**ONSITE SEWAGE DISPOSAL SYSTEM DESIGN PLAN**  
**ALLNUT FARM ESTATES, SECTION-4**  
**LOTS 15**  
 PLAT No. 4623  
 13488 OPEN SPACE COURT, HIGHLAND, MD 20777  
 TAX MAP 34, GRID 15, PARCEL 375  
 5TH ELECTION DISTRICT HOWARD COUNTY, MARYLAND

**ONSITE SEWAGE DISPOSAL SYSTEM DESIGN PLAN**  
**ALLNUT FARM ESTATES, SECTION-4**  
**LOTS 15**  
PLAT No. 4623  
13488 OPEN SPACE COURT, HIGHLAND, MD 20777  
TAX MAP 34, GRID 15, PARCEL 375  
5TH ELECTION DISTRICT HOWARD COUNTY, MARYLAND

**MEMORANDUM**

**RE:** OSDS Plan  
Open Space Court, Lot 15  
Allnut Farm Estates

**PUMP CAPACITY CALCULATIONS**

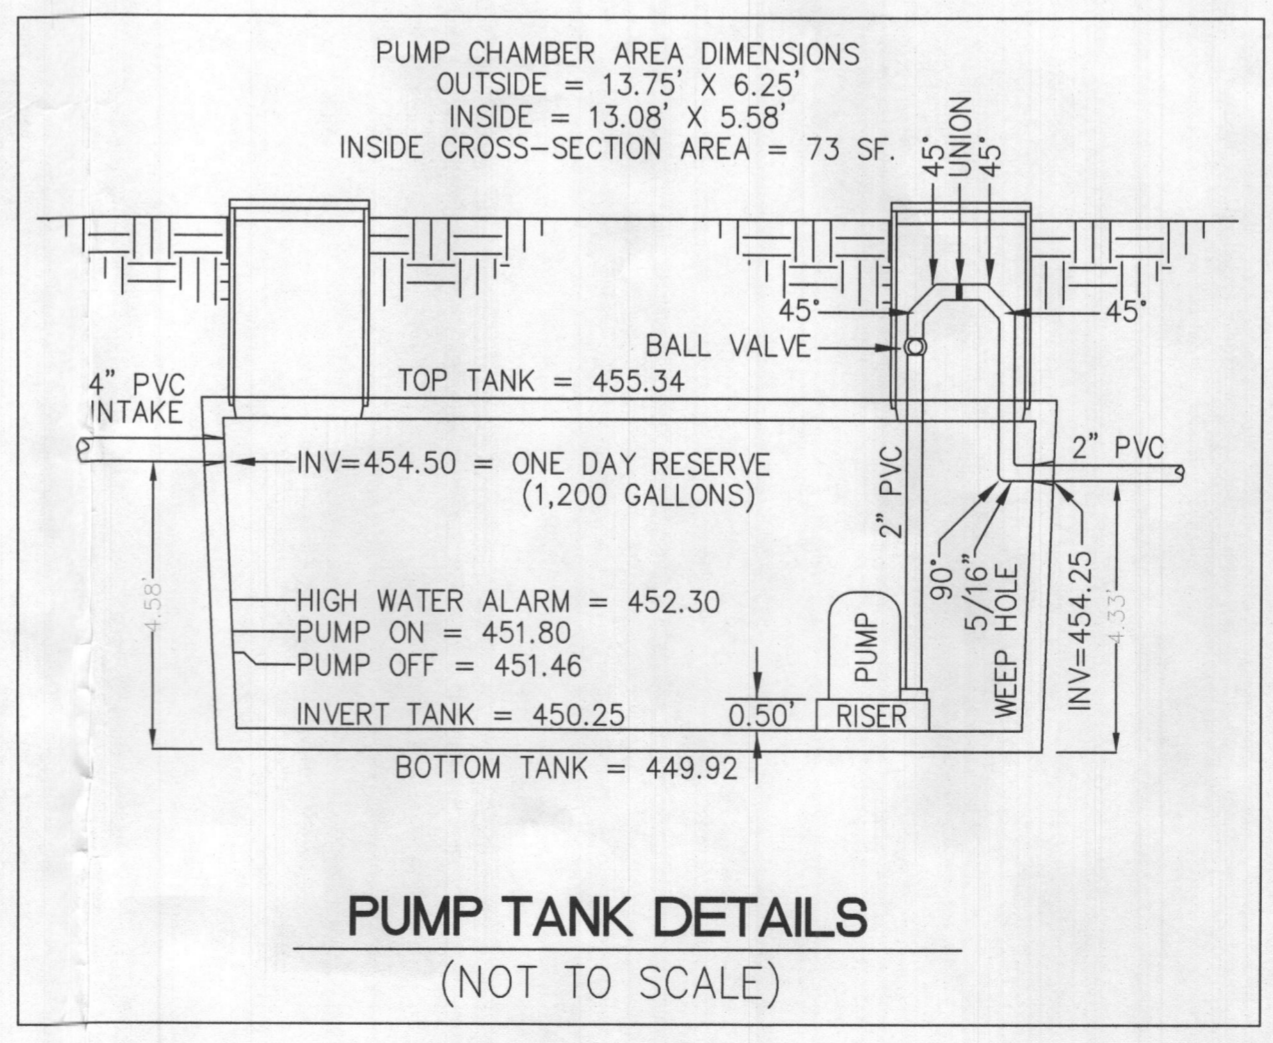
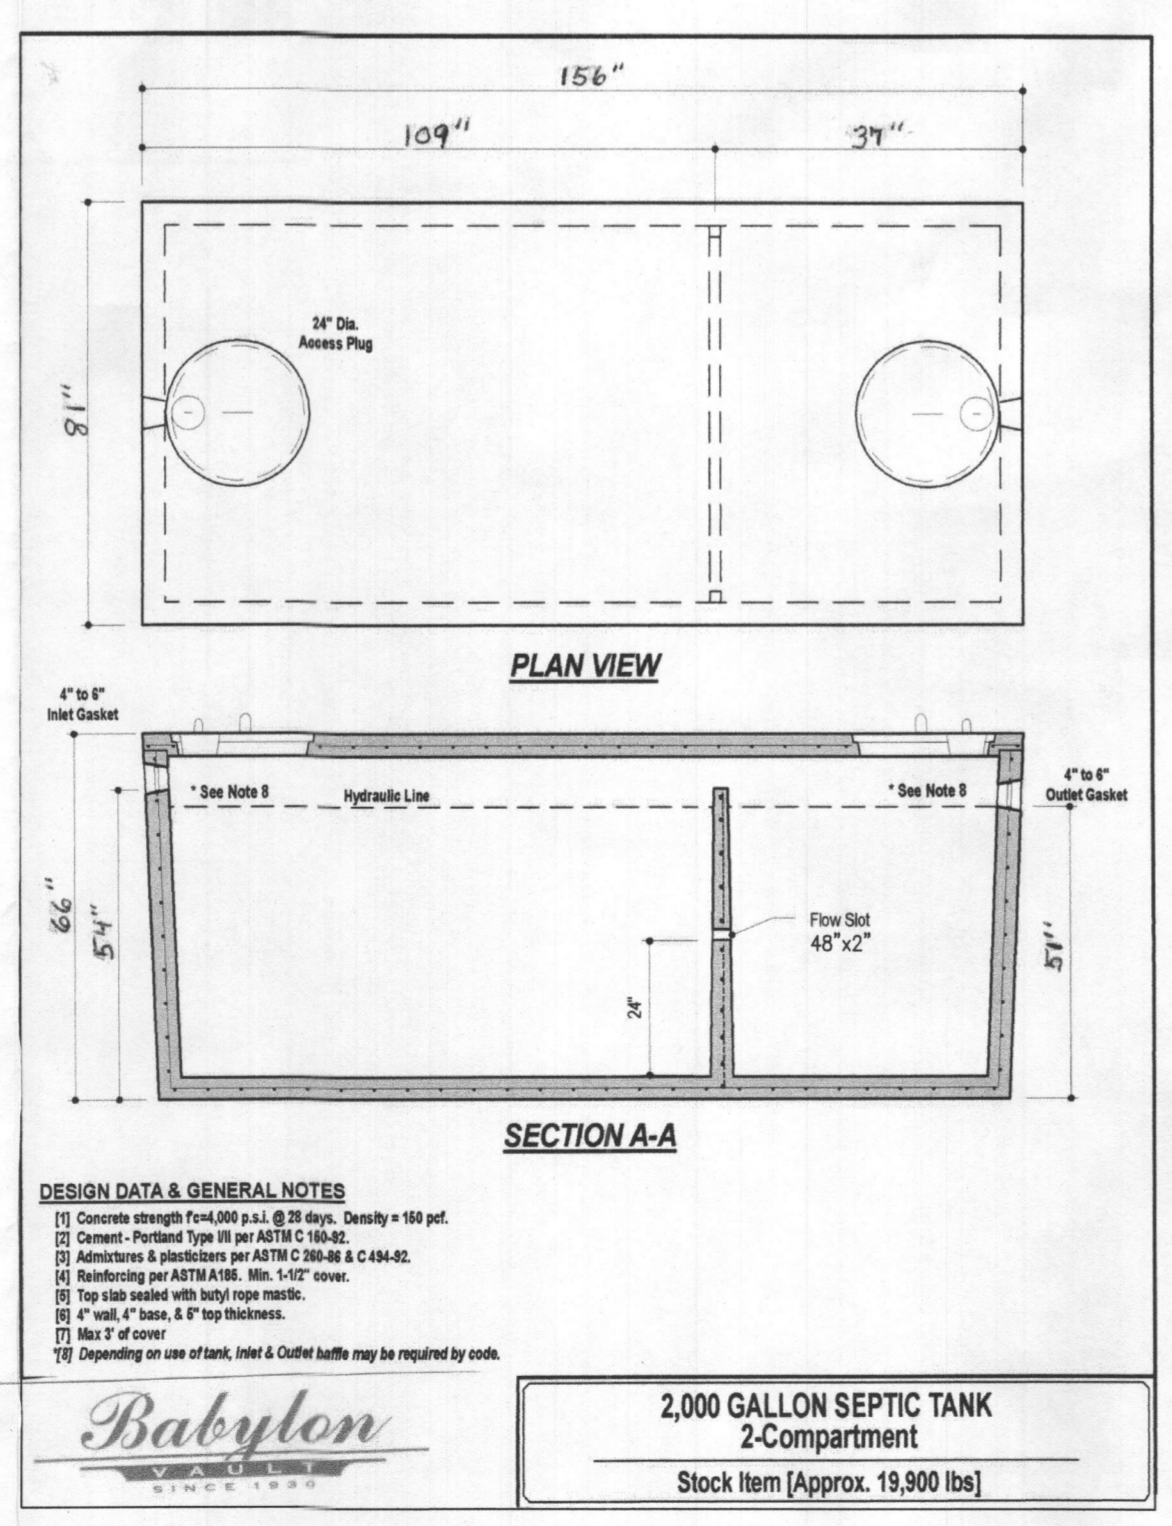
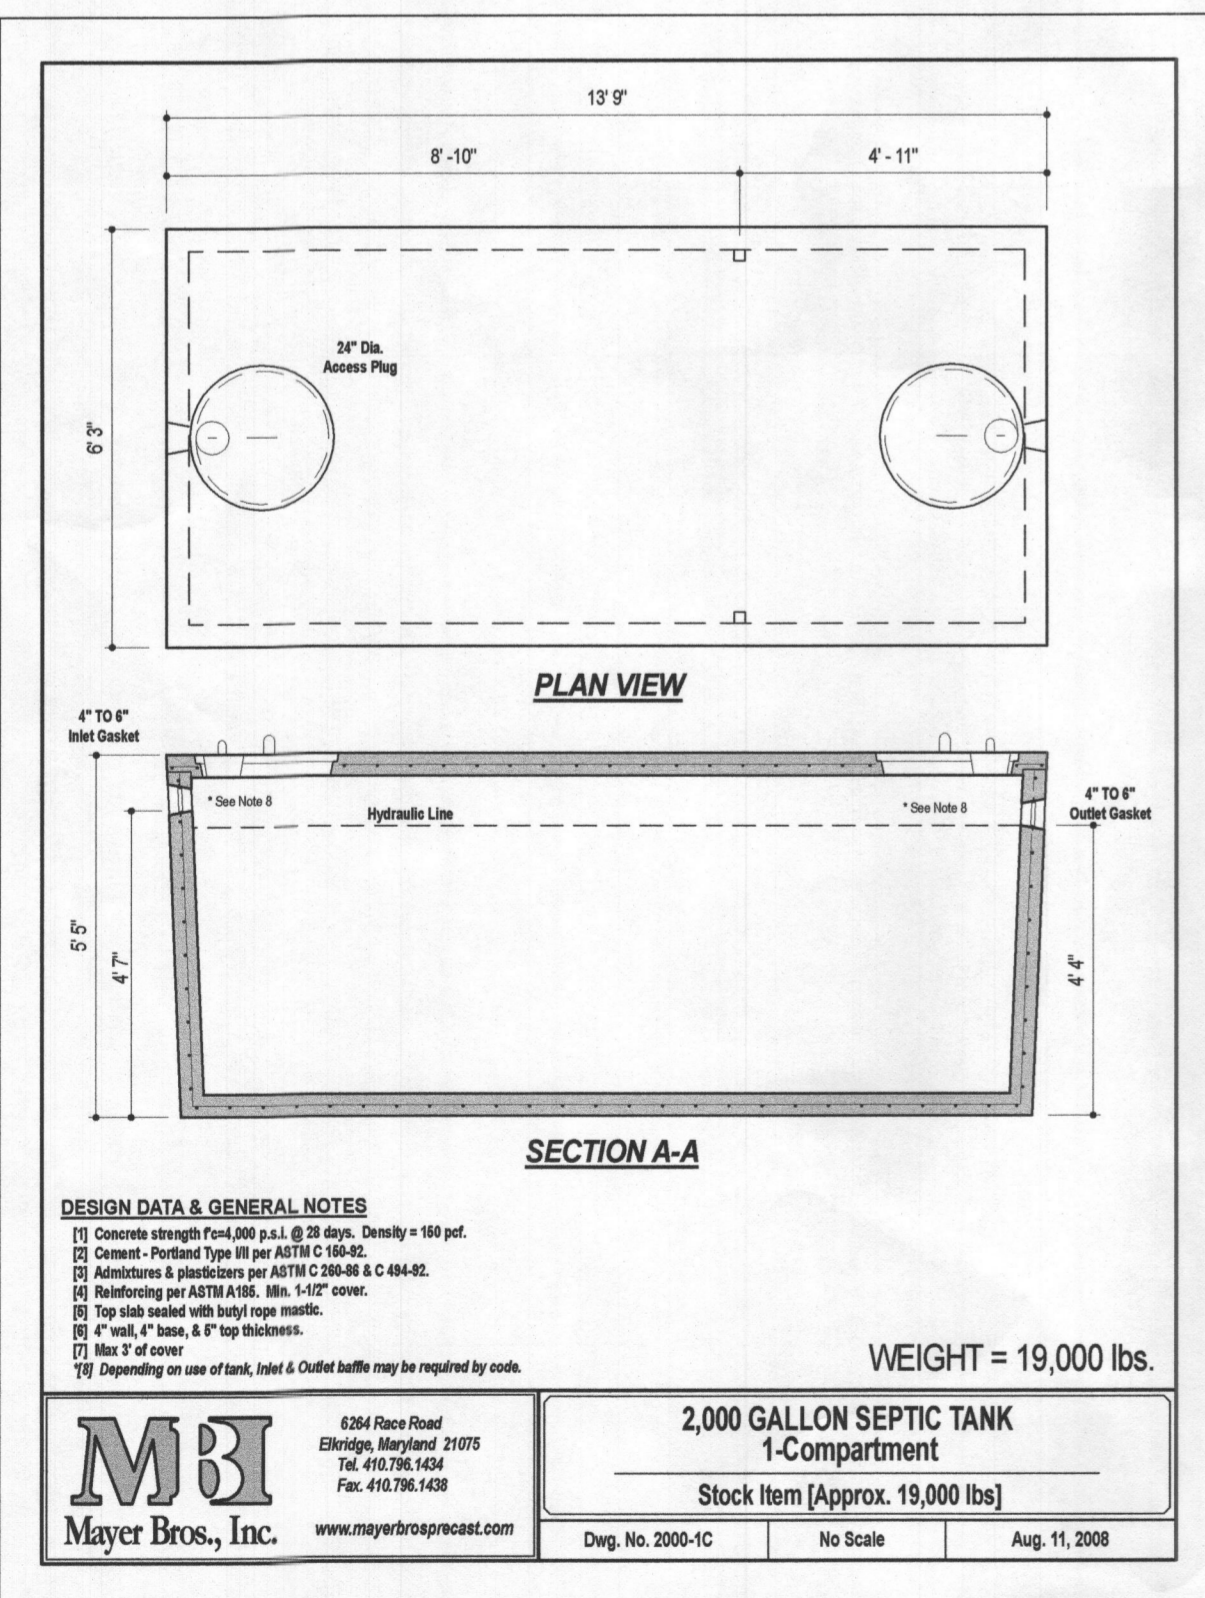
- 1.) Dose does not equal 45.5, but instead represents the volume in the FM. If you want to keep the data in the pump capacity calculations, change title to Force Main Volume = 45.5.
- 2.) 2 in. Force main should probably be in a 3-inch sleeve (not 6 in.).
- 3.) Compare friction loss in fittings with the sand mound manual chart (see attachment).

- 1.) Dose does not equal 45.5, but instead represents the volume in the FM. If you want to keep the data in the pump capacity calculations, change title to Force Main Volume = 45.5.
- 2.) 2 in. Force main should probably be in a 3-inch sleeve (not 6 in.).
- 3.) Compare friction loss in fittings with the sand mound manual chart (see attachment).

- 4.) Change the terminology in the pump capacity calculations on page #2:
  - a.) The term “Minimum system discharge rate” is incorrect. Instead use the term “Dose”. Considering the # of bedrooms for this project, it should be about 150 gallons, 150 (Recommended Dose) – 45.5 (vol. in 2 in. FM) = 104.5. 104.5 gallons will make it to the d-box after the force main is charged. It doesn't have to be 200 gallons as previously stated since this isn't an LPD design.

**FORCE MAIN VOLUME:**  
FORCE MAIN (2") 281.2 X 17.4 GAL/100 LF. = 45.5 GALS.

**FRICITION:**  
MAIN + FITTINGS = 261.2 + 36.0 = 297.2  
297.2 ( 3.98/100 ) = 11.83

**TDH (TOTAL DYNAMIC HEAD)** (11.83 + 19.34) = 31.17 @ 150 GPM  
**RT (PUMP RUN TIME)** (2.5-3 MINUTES @ 75 GPM)

#### PUMP CAPACITY CALCULATIONS

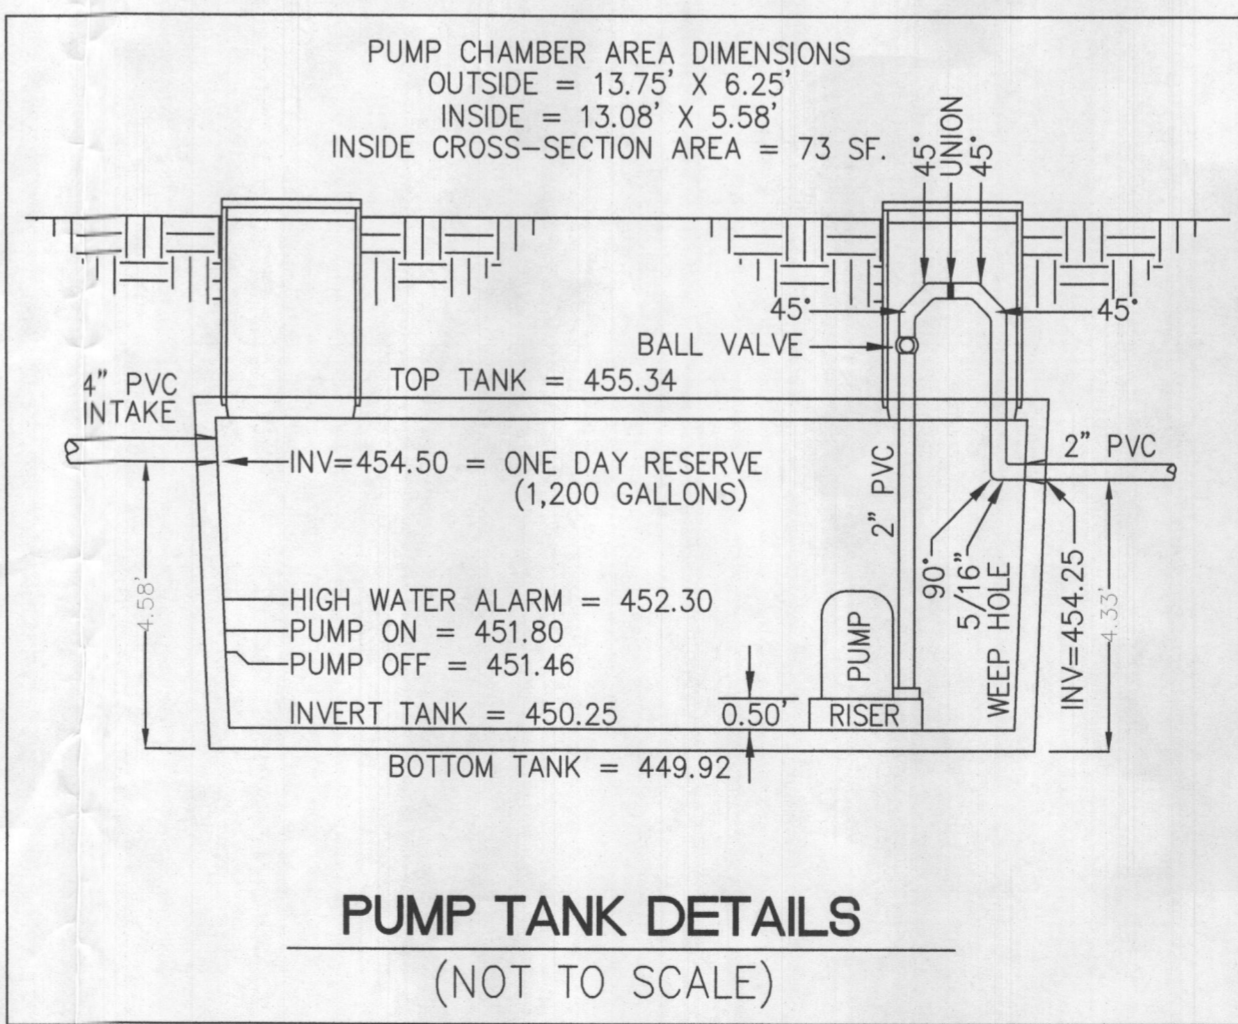
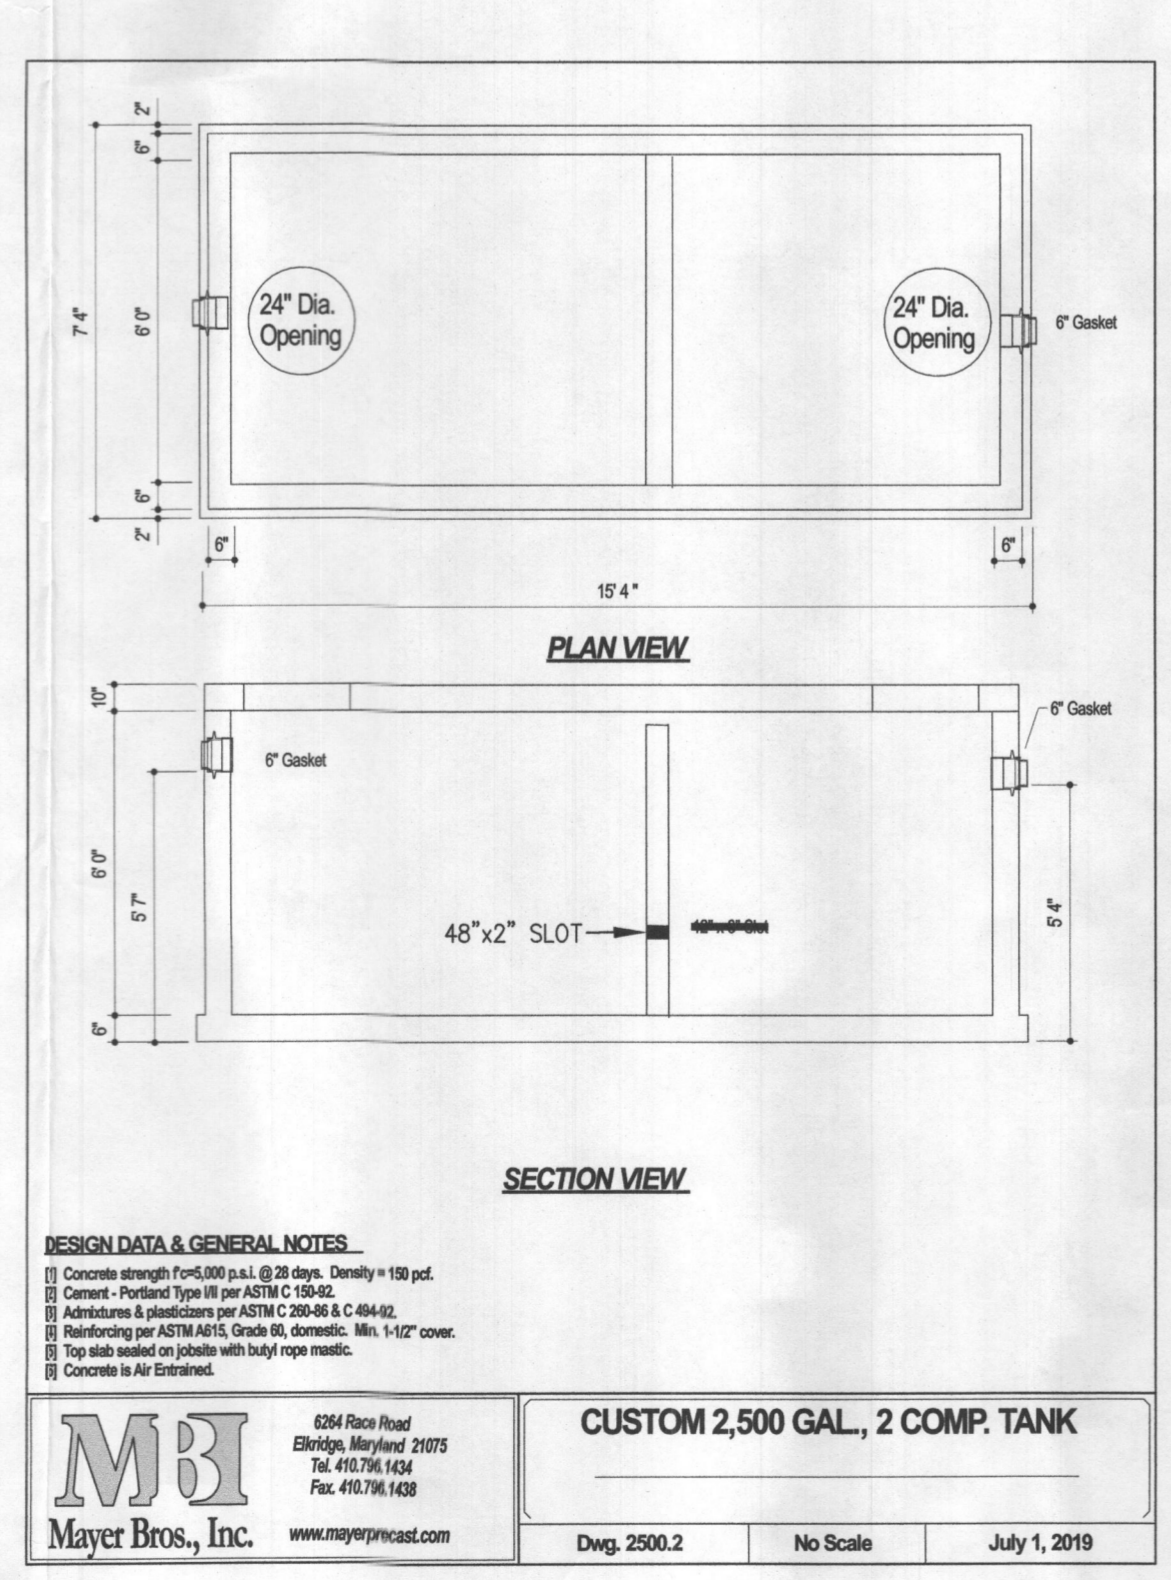
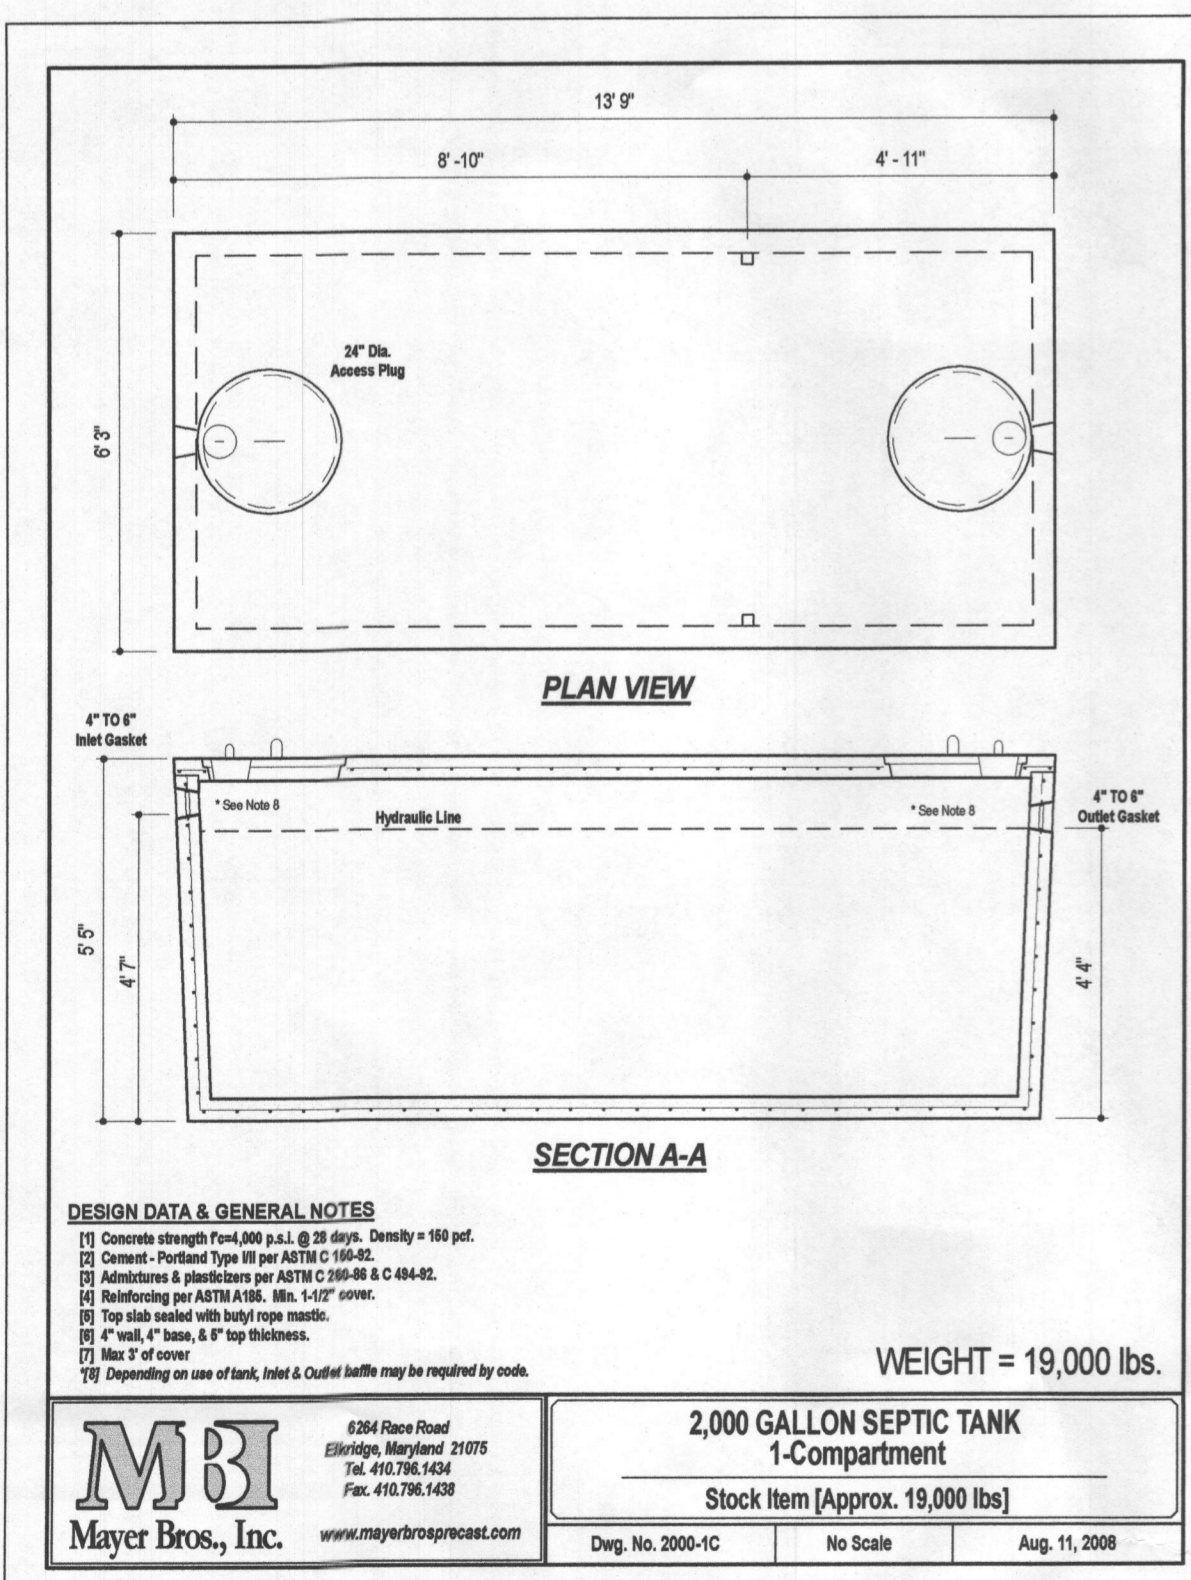
Can you please look through the Pump Capacity Calculations on sheet 2 of the revised attached OSDS plan? I found conflicting friction numbers for the 2" fittings and would like to make sure that the numbers used are adequate before we re submit for review.
